Access Compliance Report Public Rights-of-Way (Curb Ramps)

Intersection ID: 23398 Main Street: SHARON_RD_WEST Cross Street: BRANDON_FOREST_DR Location: SE

ADA ID: 5C222A5CD834 Ramp Type: PerpDiag Initial Pass/Fail: Fail Overall Compliance: No Severity Score: 13.75

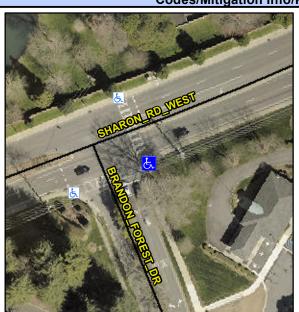
Not Found, R304.2.2

Field Measurements/Component Compilance						
	Compliance Description		Data	Compliance Description		Data
	N/A	Ramp Length (in)	60.0	No	Ramp Slope (%)	8.5
	Yes	Ramp Width (in)	48.0	Yes	Ramp XSlope (%)	2.5
	N/A	Flare Type LT	N/A	N/A	Flare Type RT	N/A
	N/A	Flare Slope LT (%)	N/A	N/A	Flare Slope RT (%)	N/A
	N/A	Flare Traversable LT?	N/A	N/A	Flare Traversable RT?	N/A
	N/A	Landing Length (in)	N/A	N/A	DWS Provided?	N/A
	N/A	Landing Width (in)	N/A	N/A	DWS Contrast?	N/A
	N/A	Landing Slope (%)	N/A	N/A	DWS Length (in)	N/A
	N/A	Landing X Slope (%)	N/A	N/A	DWS Full Width?	N/A
	N/A	Landing Curb? (Y/N)	N/A	N/A	DWS Offset (in)	N/A
	N/A	Shared Landing?	N/A			
	N/A	Gutter Ponding?	N/A	N/A	Gutter Slope (%)	N/A
	N/A	Gutter Lip Ht (in)	N/A	N/A	Gutter X Slope (%)	N/A
	N/A	Painted X Walk1?	Yes	N/A	Painted X Walk2?	Yes
		X Walk 1 Direction	To NW		X Walk 2 Direction	To SW
	N/A	X Walk 1 Width (in)	111.0	N/A	X Walk 2 Width (in)	113.0

Remove & Replace Curb Ramp With Two New Directional Ramps or Equivalent.
